# UNITED STATES PATENT AND TRADEMARK OFFICE

| APPLICATION NO.  | FILING DATE | FIRST NAMED INVENTOR | ATTORNEY DOCKET NO. | CONFIRMATION NO. |
|--|-------------|----------------------|---------------------|------------------|
| 10/048,165   | 01/29/2002  | Martin Caldwell      | 741890-0023         | 4375             |

## Office Action Summary

## DETAILED ACTION

**Fig. 2B**

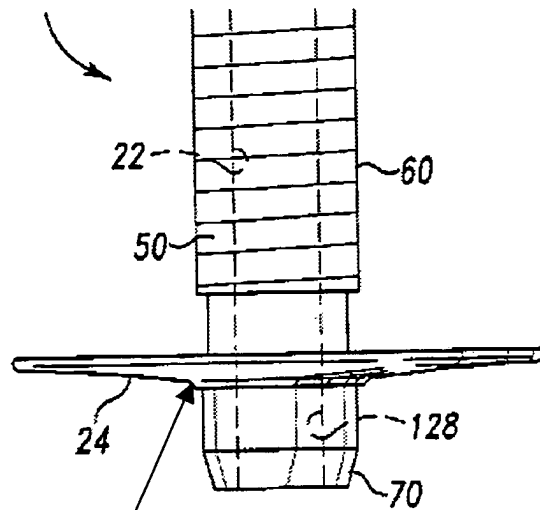
16. Regarding Claim 18, the entry port (central hole in seal 24) has a conical section, as is evident in the below drawing:

Conical  
flange
